DUKE POWER COMPANY

Re: Catawba Nuclear Station
Docket Nos. 50-413 and 50-414

My letter of January 20, 1982 transmitted a list of Action Items which was compiled during a December 15-18, 1981 meeting with the Structural Engineering Branch. Responses to these Action Items are attached except for Items 27, 31, and 32 which will be provided by May 7, 1982.

DESIGN RESPONSE SPECTRUM,
 .15g
 CATAWBA NUCLEAR STATION
 FIGURE 2.5.2-7
 OVER PLOT OF REGULATORY
 GUIDE 1.60 USING
 QUESTION 230.3 AT STARTING: .12g

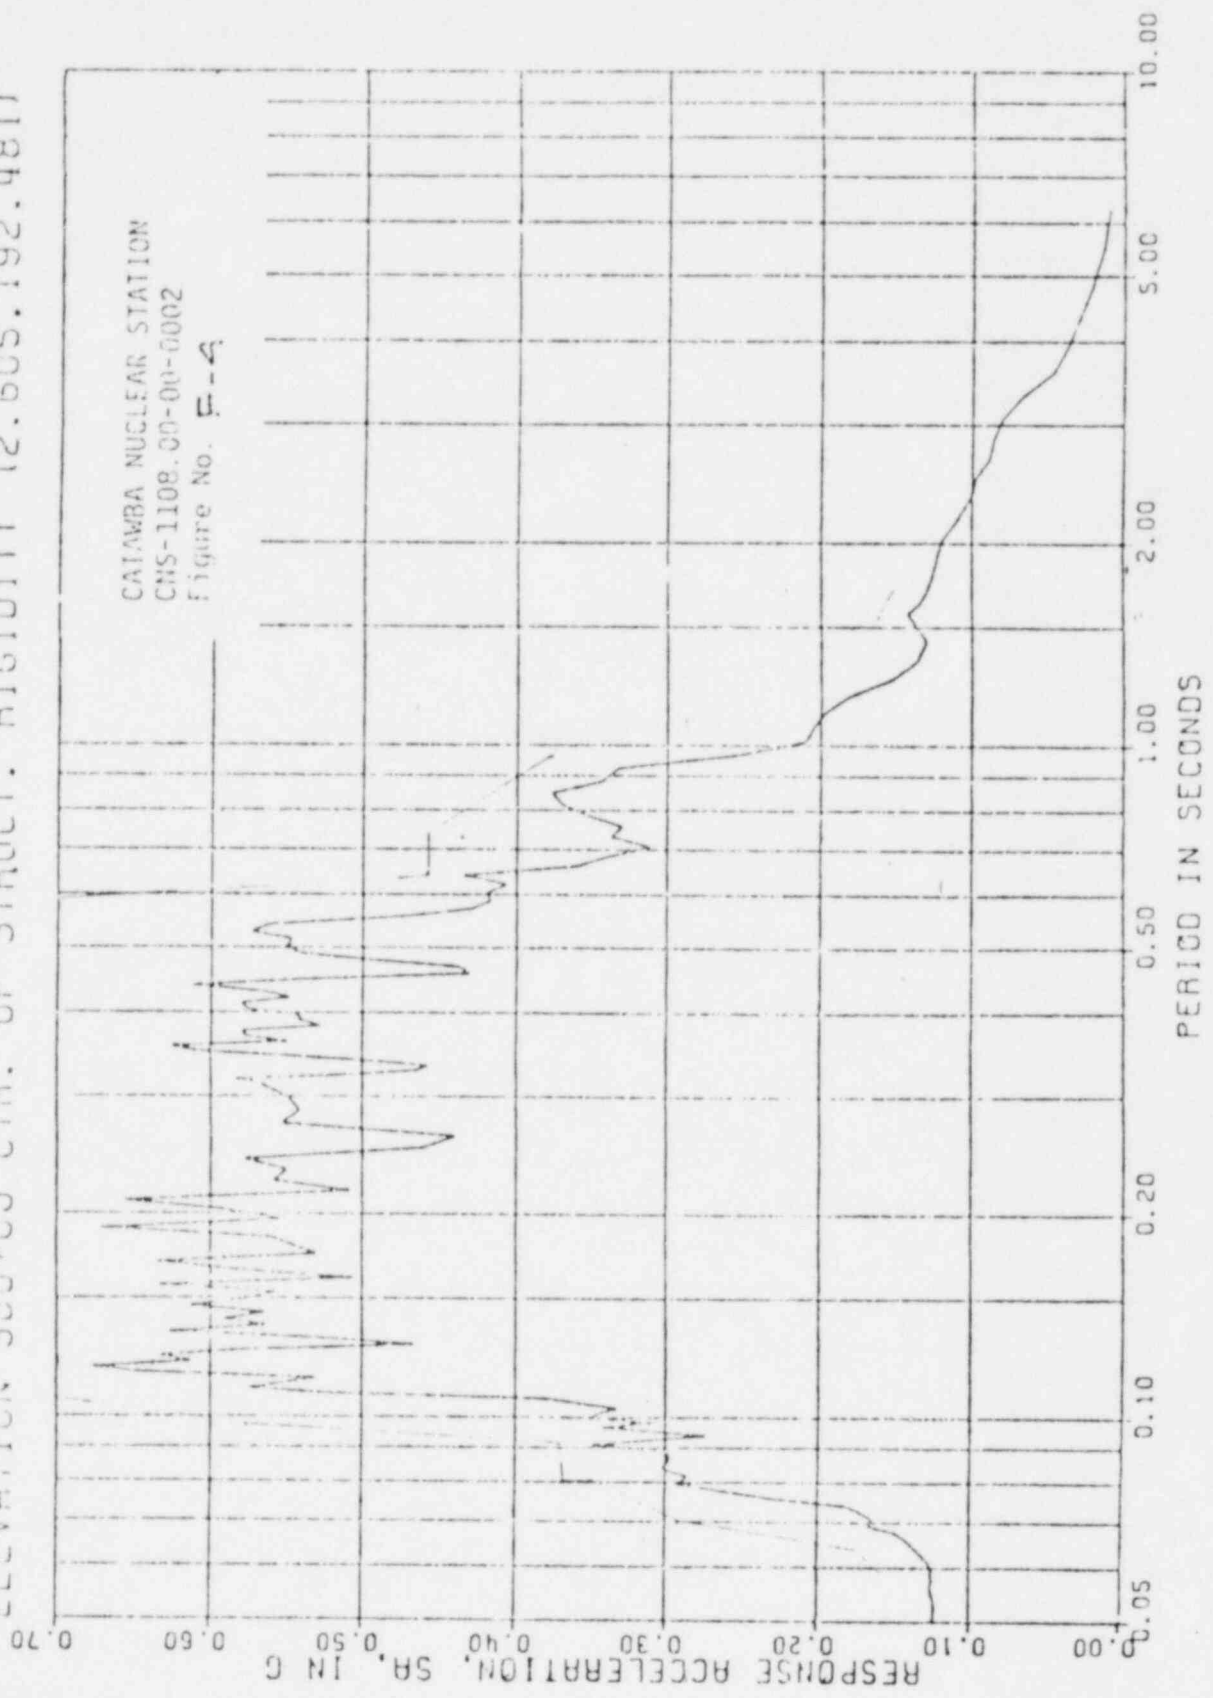
1. With respect to groundmotion response spectra, Duke will provide a comparison of the Catawba design with respect to Regulatory Guide 1.60 and address and justify deviations therefrom.

The design ground response spectra obtained from the procedures outlined in Regulatory Guide 1.60 are plotted against the spectra used for the Catawba design in the attached figure.

The curves of interest are the 2% and 5% damping curves. The 2% curve is used for welded steel structures and the 5% curve is used for concrete structures. The lowest first mode frequency of any Category one structure is 5.4 cps. Therefore, comparison will be made from the 5.4 cps frequency level and higher.

For the 5% damping curve, the Catawba design acceleration spectra envelopes or equals that resulting from the Regulatory Guide 1.60 criteria.

In the frequency range above 12.5 cps on the 2% damping curve, the Catawba design acceleration spectra equals that resulting from the Regulatory Guide 1.60 criteria. Between 12.5 cps and 7.7 cps, on the 2% curve, the Regulatory Guide criteria envelopes the Catawba design criteria. (The maximum discrepancy is 5% in this frequency range with the average difference being less than 2.5%.) In the frequency range between 7.7 cps and 5.4 cps, the Catawba design acceleration spectra envelopes that resulting from the Regulatory Guide 1.60 criteria.

In conclusion it is noted that the Catawba design response spectra is not based on Regulatory Guide 1.60 criteria but compares very favorably to it.

STEAM GENERATOR
(1770)

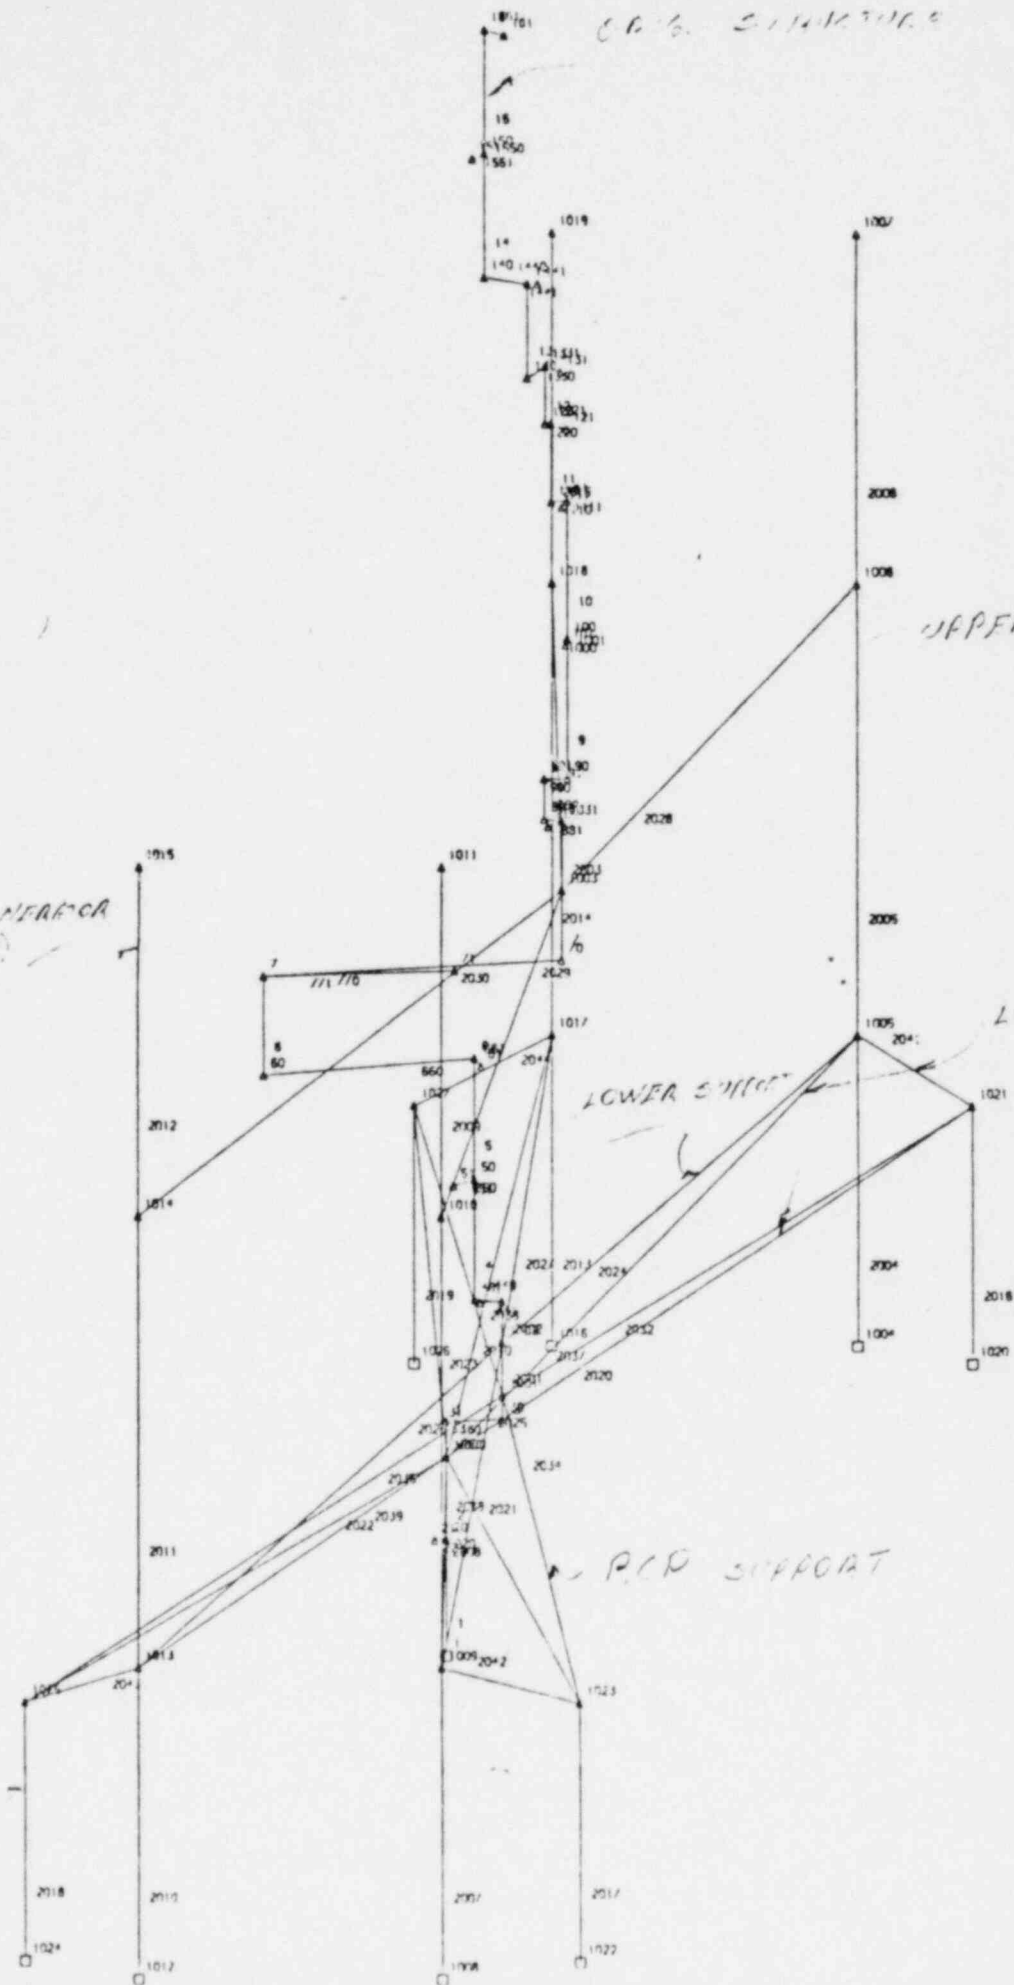
5. Provide justification for not including support stiffnesses of key NSSS components in the seismic model of the interior structure. Also, discuss how the requirements of Standard Review Plan 3.7.2.II-3b are met.

The Standard Review Plan Section (3.7.2) now in effect requires that an approximate model of the NSSS be coupled with the model of the primary supporting structure. The following assumptions were made in the development of the NSSS model:

Figure 1 (attached) shows the resulting model configuration.

- The resulting structural design forces would drop from 10 to 15% over the values used in the original design.
- The resulting response spectra would show a frequency shift of 5 to 10% toward the low frequency side of the curve. The resulting response should fall within the present spectra envelope.
